**Subject: Response to Portion of NRC RAI Letter No. 166 Related to ESBWR Design Certification Application - DCD Tier 2 Section 3.8 – Seismic Category I Structures; RAI Number 3.8-96, Supplement 3**

1. Response to Portion of NRC RAI Letter No. 166 Related to ESBWR Design Certification Application - DCD Tier 2 Section 3.8 – Seismic Category I Structures; RAI Number 3.8-96 S03

**RAI Number 3.8-96 S03**

Figure 3.8-96(1) Horizontal Forces in Sliding Evaluation (Basemat Plan)

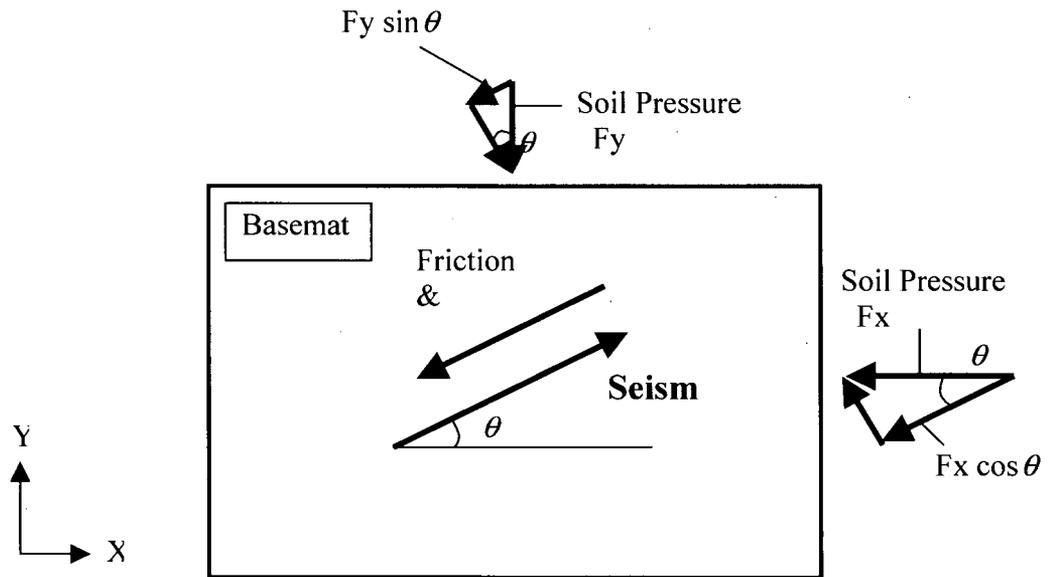
Applied horizontal seismic forces and sliding resistances are schematically shown in Figure 3.8-96(1). Among the resistances, the basemat bottom friction and cohesion act in the direction of the resultant seismic force and their magnitudes are the same as those in the 2-dimensional evaluation.

Figure 3G.4-11. ~~Shear Keys and Concrete Backfill in Sliding Evaluation~~ Deleted

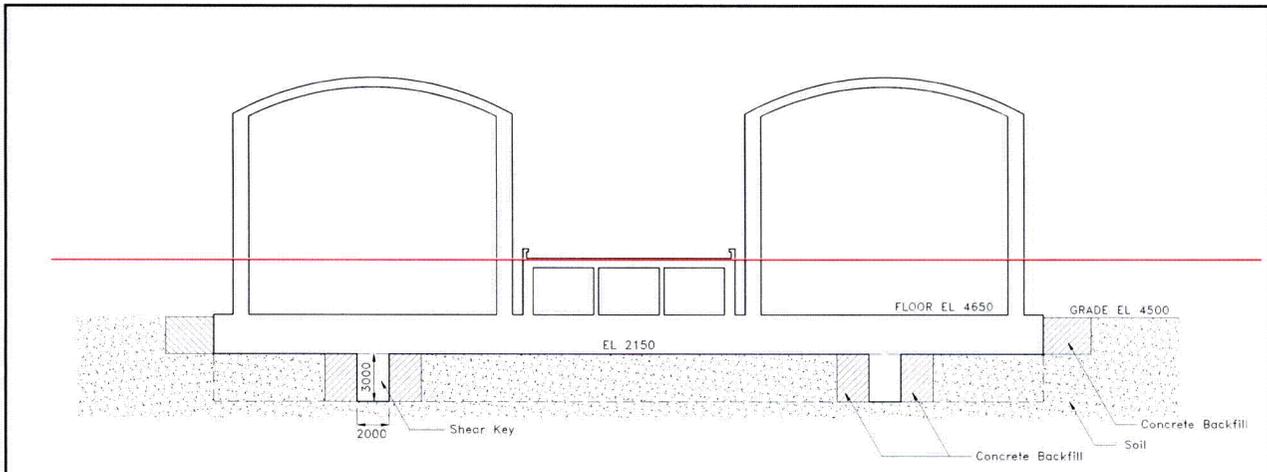
The factors of safety against overturning, sliding and floatation are given in Table 3G.4-22. All of these meet the acceptance criteria given in Table 3.8-14. Shear keys under the basemat shown in Figure 3G.4-1 are used to resist sliding. ~~In addition, the gap between the basemat and excavated soil is backfilled with concrete up to the grade level as shown in Figure 3G.4-11.~~

Note: ~~Excavation and backfill method is determined considering actual site conditions.~~
